INDESIT company

Model type:
SD1722VHA

Commercial code:
F053530

n2508g00: GRAB HANDLE FIXING SCREWS & WASHERS

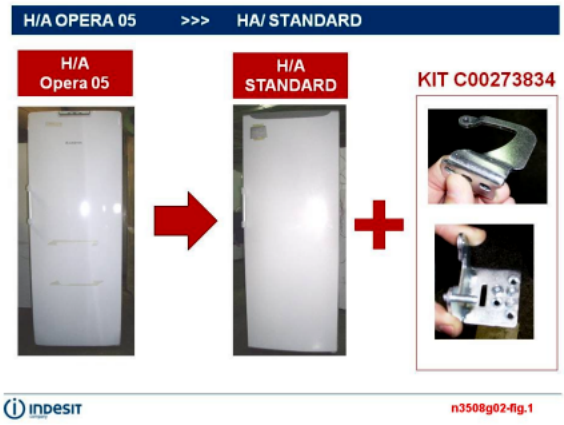
n2508e03: DOOR SUPPLIED - ALSO REQUEST LOGO

This door is not supplied with the logo/badge. Therefore, when requesting a replacement door for this appliance you should also request a new logo/badge.

Wherever a grab handle is to be replaced; new screws and washers as listed in the parts list should also be fitted.

n2509h00: DOOR CHANGE -FRIDGES

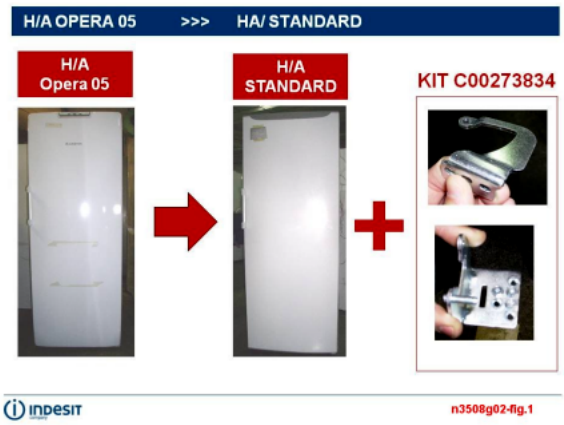
n2509g01: DOOR CHANGE

To Identify the correct parts refer to the Image in Partfinder and/or Service Net showing both the OLD & NEW Aesthetic Doors.
GRAB HANDLES -
MODELS with OLD Aesthetics - BEFORE SERIAL NUMBER COMMENCING 80712…. (12 July 2008) The grab handle used with this door has 2 screw fixings; 2 washers were introduced later (listed in the parts list). Where it is necessary to replace this type of grab handle, 2 screws and 2 washers should also be ordered and fitted. When stock of this Grab Handle becomes depleted a NEW Aesthetic DOOR & DOOR CONVERSION KIT will be required.
MODELS with OLD Aesthetics - AFTER SERIAL NUMBER COMMENCING 80713…. (13 July 2008) The grab handle used with this door has 3 screw fixings, compared to the original mentioned above, which has only 2. This handle is a seal break handle and is NOT inter-changeable with the previous handle or door
DOORS -
OLD Aesthetic DOORS are NO LONGER AVAILABLE for the above models. A NEW Aesthetic DOOR is available and is inter-changeable with the OLD Aesthetic MODELS mentioned above. Where there is a colour trim option to choose from, it will be shown in the description of the relevant door. NOTE: A DOOR COVERSION KIT C00273834 will be required if this door is to be fitted to an OLD Aesthetic model. The DOOR CONVERSION KIT consists of the following: 2x Hinge Pin Cover Grey (Argento), 2x Hinge Pin Cover Silver (Argento Vivo), 2x Hinge Pin Cover Stainless Steel (Inox), 1x Hinge Bush, 1x Cover Strip, 1x Grab Handle (3 Fix Grey & Silver), 3x Grab Handle screw, 3x Grab Handle washer, 1x Closure Aid (L/H), 1x Lower Hinge Pin, 1x Lower Hinge, 1x Upper Hinge screw, 1x Upper Hinge, 1x Lower Hinge Fixing Plate. The logo/badge is not included. Therefore, when requesting a replacement door for this appliance you should also request a new logo/badge.

3 fixing hole type GRAB HANDLE SHOULD NOT BE USED ON DOORS/MODELS PRODUCED BEFORE serial number

80712…., UNLESS IT HAS THE NEW Aesthetic DOOR ALREADY FITTED.
DISCLAIMER: The part supplied may differ from the original in colour, form or content, but is considered to be an acceptable interchangeable alternative. In accordance with its policy of progressive product design and environmental protection, Indesit Company reserves the right to alter specifications and use quality recycled components.

To Identify the correct parts refer to the Image in Partfinder and/or Service Net showing both the OLD & NEW Aesthetic Doors.
The doors being supplied are of the new aesthetic type and may require a conversion kit.
The conversion kit is only required if you are changing from old aesthetic to new aesthetic doors. (This is not required for door reversal)
